Re: Chemical Recovery Systems
Elyria, Site Inspection

RE: Comments made by Greg Kulma and Kevin C. Garrahan on the
Hydrogeologic and Extent of Contamination Study for Chem-
ical Recovery Systems

SUBJECT: Review Comments Chemical Recovery Systems, Inc.
Hydrogeologic and Extent of Contamination Study

SUBJECT: Peer Review of E & E Hydrogeological Study of Chemical
Recovery Systems - Elyria, Ohio

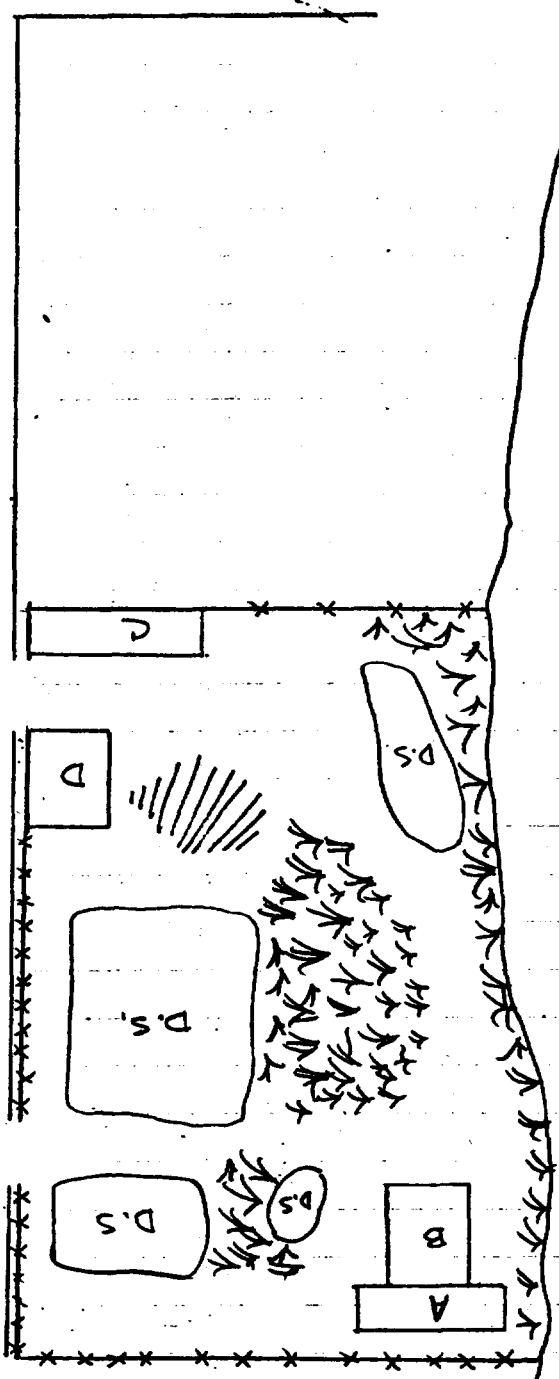
As a result of our inspection, we agreed that those areas designated as D.S. on the enclosed site map, required removal of the top layer of soil prior to grading and seeding. The basis for this decision was the fact that no vegetation existed in those areas as it did in other areas of the site. Also, small areas of what appeared to be residue from spilled drum contents, were observed in the drum storage areas. Your approach of scraping the surface of the entire site, for removal of the top layer of soil and other miscellaneous debris is acceptable and will satisfy the need to have such soils removed.

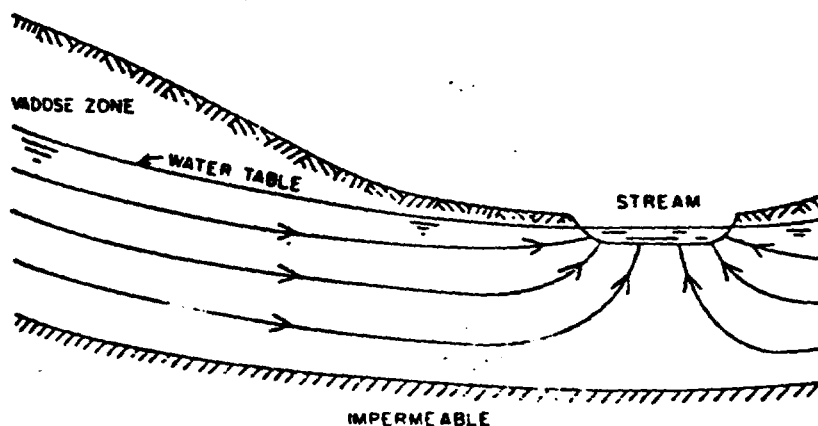
Calculations for groundwater flow are based on an assigned permeability value and the river depth of eight feet. The river depth should not be used to calculate the cross-section area normal to the flow since the flow lines converge to the sides and bottom of the stream (see sketch below).

Since the characteristics of the underlying sandstone aquifer are not known, then perhaps it would be best to calculate the flow of groundwater through the layer of unconsolidated fill. In this case, the maximum thickness of fill (28 feet) would be used in Darcy's Equation. Computation of the equation would yield the maximum flow of contaminated groundwater through the site.

Pertaining to his comments on using the entire stream bottom as the area perpendicular to flow, in the flow rate calculation:

- 1) The example figure he gives does not resemble the conditions at the site.
- 2) The Black River is not the major discharge area for groundwater.
- 3) Besides these facts, the thickness that would be used to calculate the flow rate through the fill would be the saturated thickness not the maximum thickness of fill (28 feet).
